AA 76-05
VAR

**STATE OF MARYLAND
CRITICAL AREA COMMISSION
CHESAPEAKE AND ATLANTIC COASTAL BAYS**
1804 West Street, Suite 100, Annapolis, Maryland 21401
(410) 260-3460 Fax: (410) 974-5338
www.dnr.state.md.us/criticalarea/

Re: Case No. 2005-0008-V William Trevillian (Lot 2)
Case No. 2005-0005-V Gary Lenz (Lot 1)

PROPOSED
SITE PLAN
SCALE: 1" = 40'
DATUM: 0.0 MLW

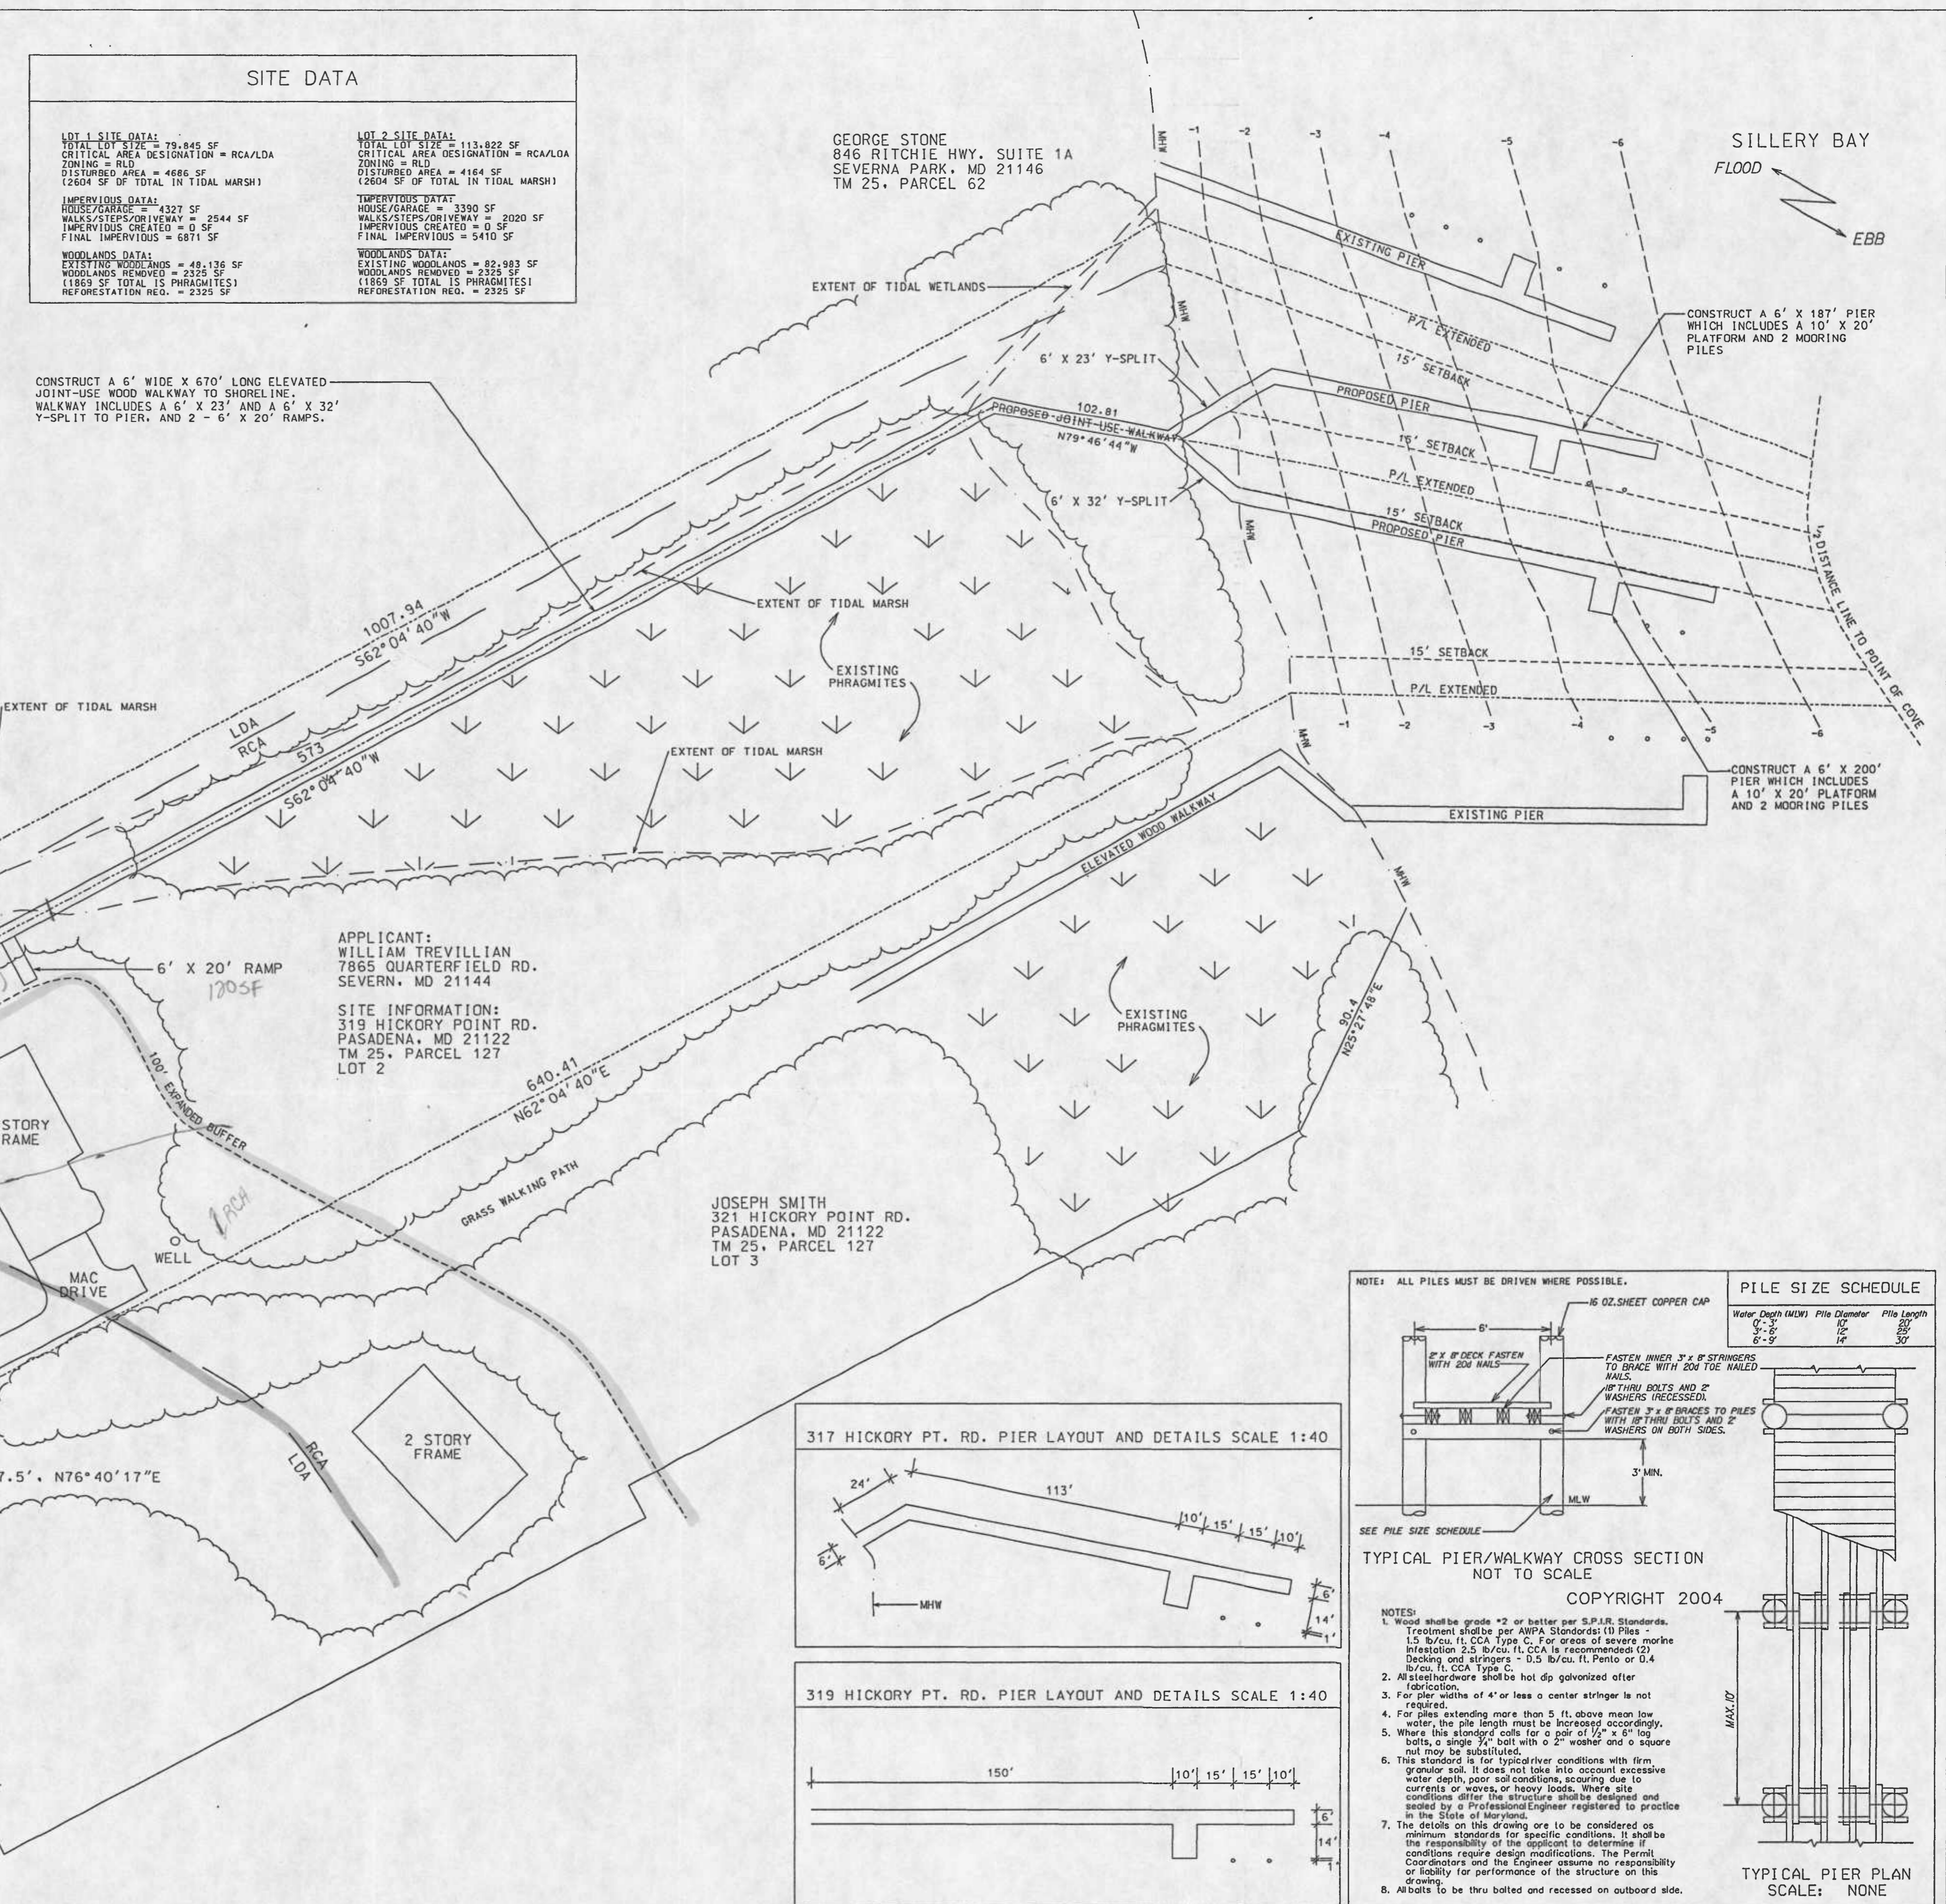
- 1) Based on the revised site plan, the extent of tidal wetlands is identified on Lot 1 and Lot 2. We note that the extent of tidal wetlands on Lot 1 and Lot 2 appears to have changed since

recording of the 1989 subdivision plat. The 100-foot Buffer (as measured from the edge of tidal wetlands) is shown incorrectly on the revised site plan. Based on the Critical Area maps for Anne Arundel County, it appears that the LDA and RCA lands on Lot 1 and Lot 2 are shown incorrectly on the revised site plan. The applicants should provide a revised site plan showing accurately the 100-foot Buffer and the LDA and RCA lands on Lot 1 and lot 2.

- 2) As shown on the revised site plan, the applicants propose the following development activities within the Critical Area: a 6 foot by 20 foot ramp on Lot 2; a 6 foot by 85 foot section of raised walkway and a 6 foot by 20 foot ramp along the property boundary of Lot 1 and Lot 2; and a 6 foot by 135 foot wood chip path (a raised walkway was proposed on the original site plan) and a 6 foot by 20 foot ramp on Lot 1. As observed during my site visit, the area of the proposed access path and walkway is relatively flat and forested (refer to the attached photographs), with the exception of the ramp on Lot 2, which is proposed in an area of mowed grass. Based on conversations with the Department of the Environment, Mr. Trevillian and Mr. Lenz have applied for a permit to construct a joint-use walkway over tidal wetlands. The walkway will connect at the shoreline to the piers proposed for each lot.

In developing Lot 1 and Lot 2, the property owners could have retained a clearing allowance to construct an access to the shoreline, particularly since the platted access easement on Lot 1 and the upland areas waterward of the dwelling on Lot 2 are fully forested. Based on the current site conditions, it appears that a joint-use access could be constructed with minimal or no clearing, if the access were limited to a 3 foot wide woodchip path or a joint access easement, wide enough to accommodate a 3 foot wide path in existing cleared areas, were provided on Lot 2 for use by both Lot 1 and Lot 2. As alternatives may exist to provide access for both Lot 1 and Lot 2 without further exceeding the clearing limits for the subdivision, this office does not support the current variance request.

- 3) As stated in the Critical Area report, 4,000 square feet of disturbance is proposed to construct a 775 foot raised walkway. As shown on the site plan, the proposed raised walkway extends within the 100-foot Buffer on Lot 1 and Lot 2 and through tidal wetlands to the mean high water line. The applicants should provide a revised site plan showing the length of the walkway located within the Buffer and calculations of the area of disturbance proposed within the Buffer as part of the current variance request.

SCD NO.	DATE	REVISIONS
	3/12/05	PER MDE/CRITICAL AREA COMMENTS
